Gas shows during drilling;  
analysis, correspondence and  
approval to proceed with  
completion

**From:** Jerry Sherrell <jerrys@mec.com>  
**Sent:** Tuesday, January 10, 2023 1:34 PM  
**To:** Rose-Coss, Dylan, EMNRD  
**Cc:** Goetze, Phillip, EMNRD; Gebremichael, Million, EMNRD; McMillan, Michael A.; Lamkin, Baylen L.  
**Subject:** RE: [EXTERNAL] Choate Davis 23 State SWD #4 SWD-2444

## Choate Davis 23 State SWD #4

Stratigraphic X-Section  
A-A'

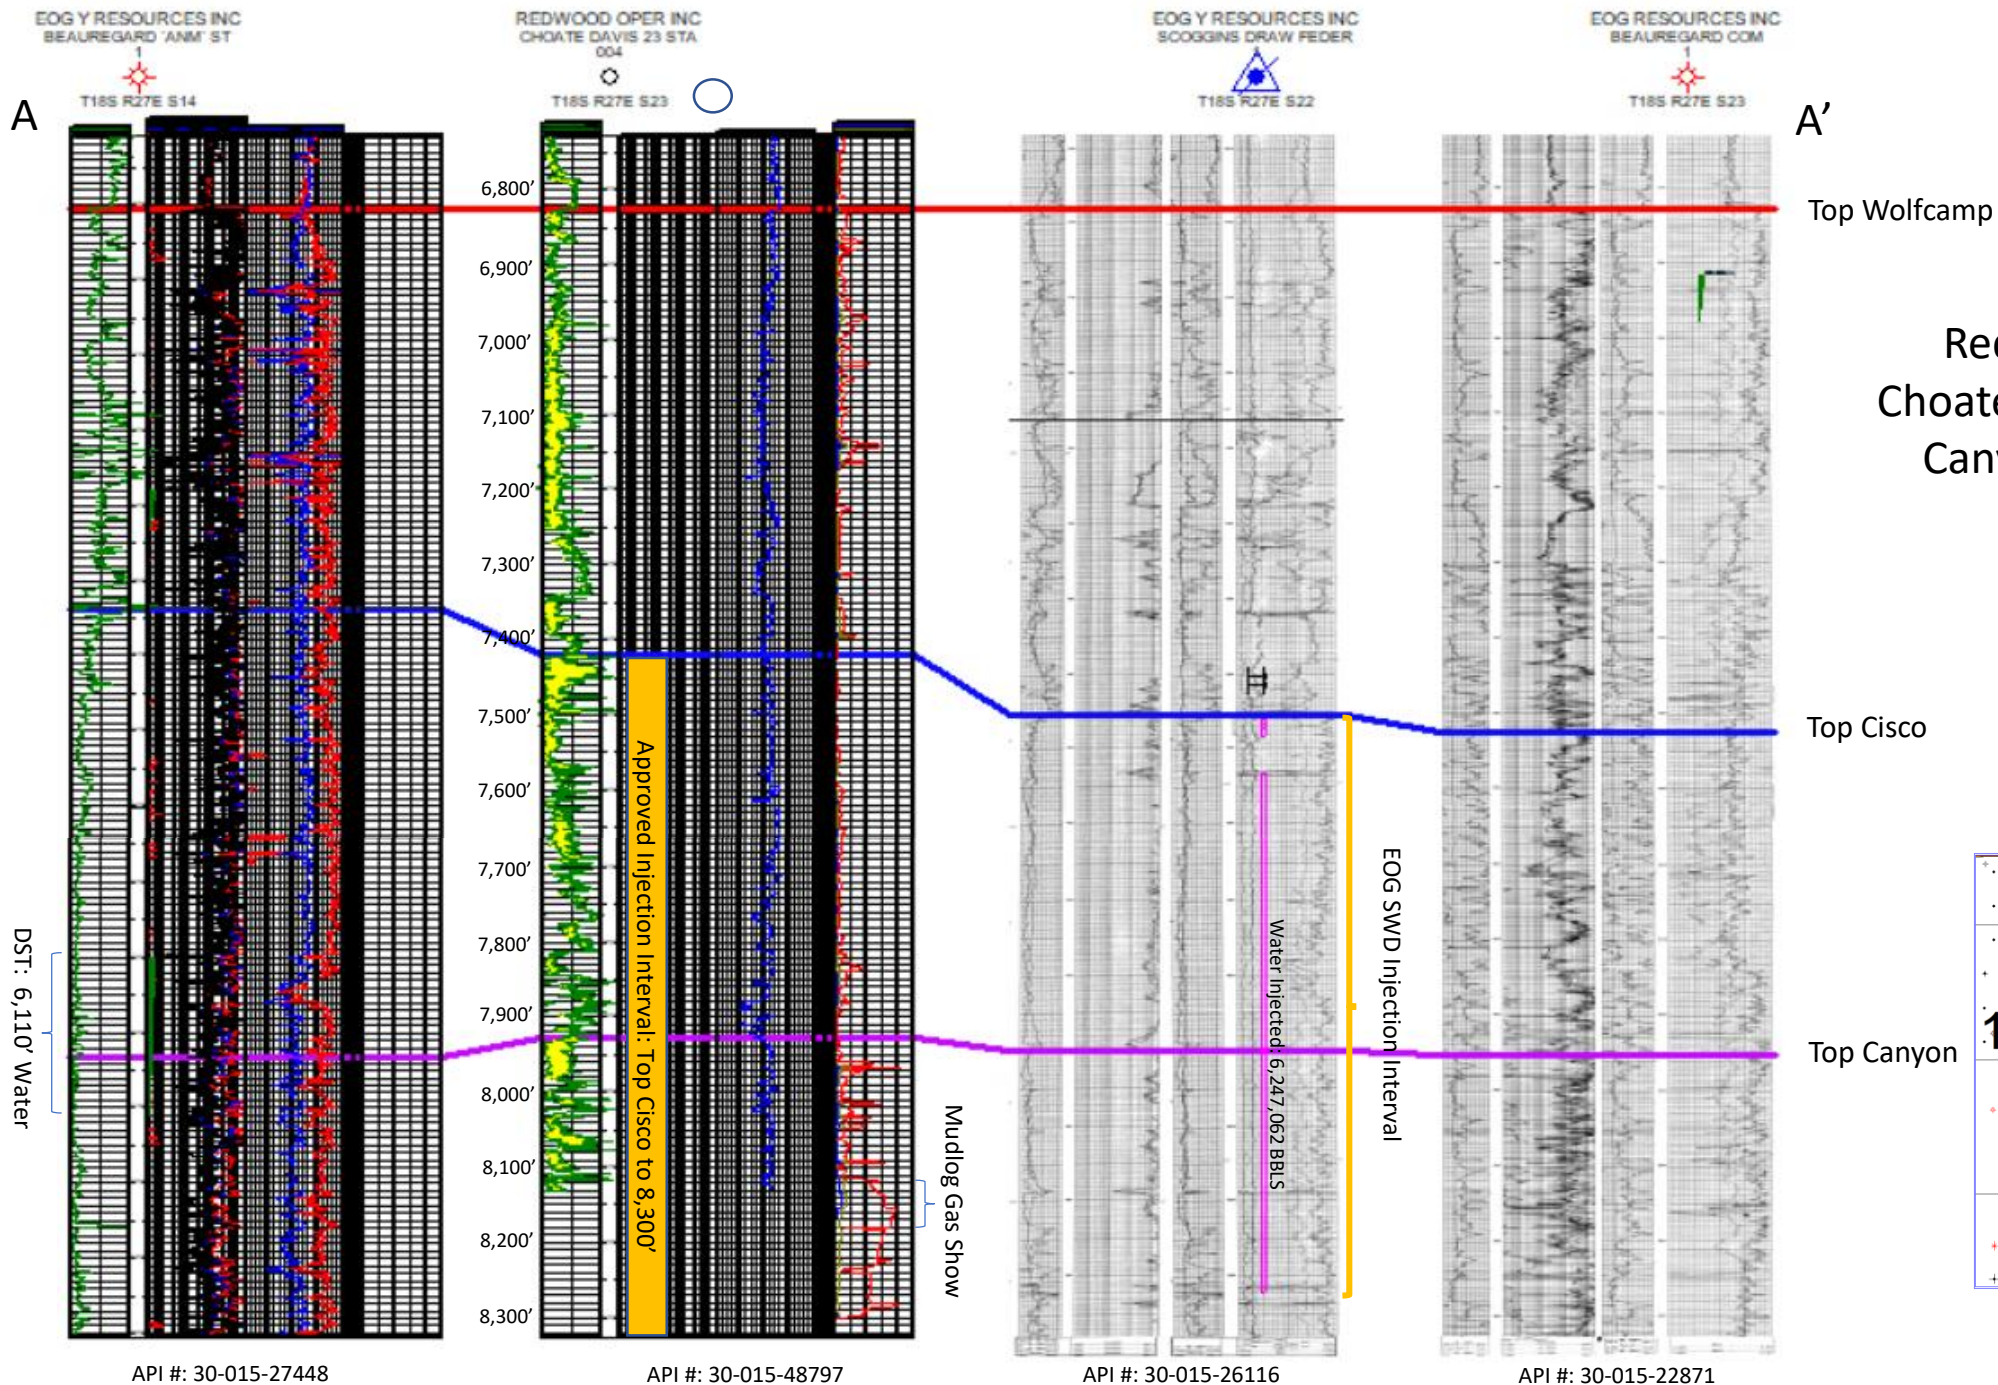
This interval is correlative with any SWD injection interval that injected over 6 million barrels.

This injection interval is downdip of Dagger Draw which produced a lot of oil gas and water  
I believe the gas shows was ancillary show in which the hydrocarbons migrated to Dagger Draw

In Slide 1, the cross section A-A' shows the Choate Davis 23 State SWD #4 is the 2<sup>nd</sup> well from the left with the approved SWD injection interval. As shown, the injection interval is below the 7,200' due to the Top of the Cisco picked at 7,422', which the approved injection formation is Cisco-Canyon. The 3<sup>rd</sup> well from the left being approximately ½ mile to the southwest was originally an EOG SWD well injecting into the Cisco-Canyon across where the mudlog show was encountered in the Choate Davis 23 SWD #4. ODC reports that 6,247,062 Barrels of water was injected into the Cisco-Canyon before the well was plugged due to casing issues. The 1<sup>st</sup> well on the left in the cross section is approximately ½ mile to the north of the Choate Davis 23 SWD #4 and reported a DST in the Cisco-Canyon with 6,110' of Water, demonstrating the zone is wet.

After internal discussion with the mineral estate owner (the State Land Office), it was determined that Redwood should proceed with completing the Choate Davis 23 State SWD #4 as planned.

Redwood Operating LLC  
Choate Davis 23 State SWD #4  
Canyon Mudlog Gas Show

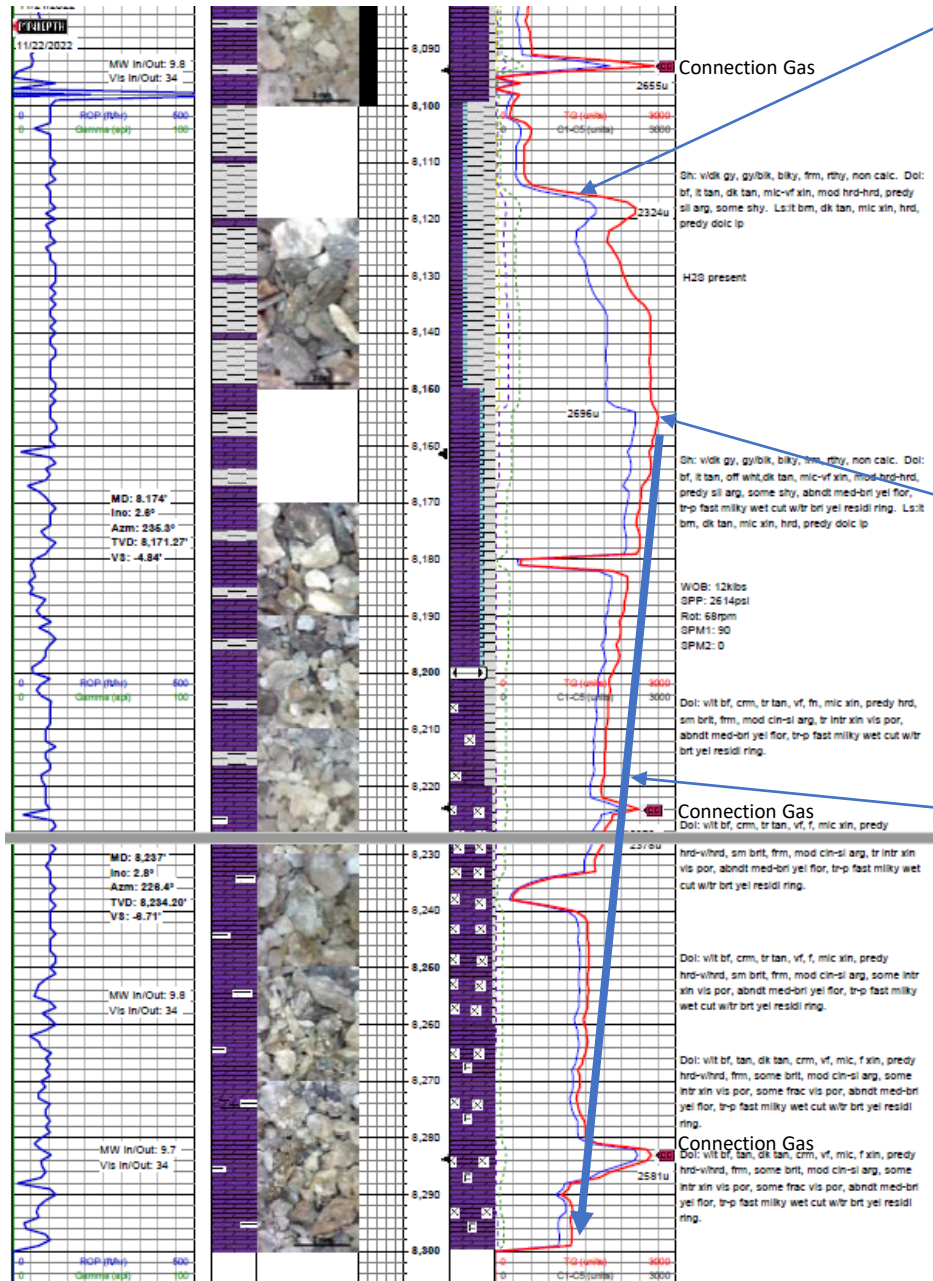
I did not see any evidence of staining or fluorescence in the mudlog

I could not see any drill breaks

In Slide 2, the gas show is defined as a Shaly Dolomite from 8,116' to 8,164' and shows the gas tapering off as the well is drilled deeper.

Gas show appears to be in a  
38' Shaly Dolomite from  
8,116'-8,164'

I think that Redwood should perforate this interval since it is part of the injection interval
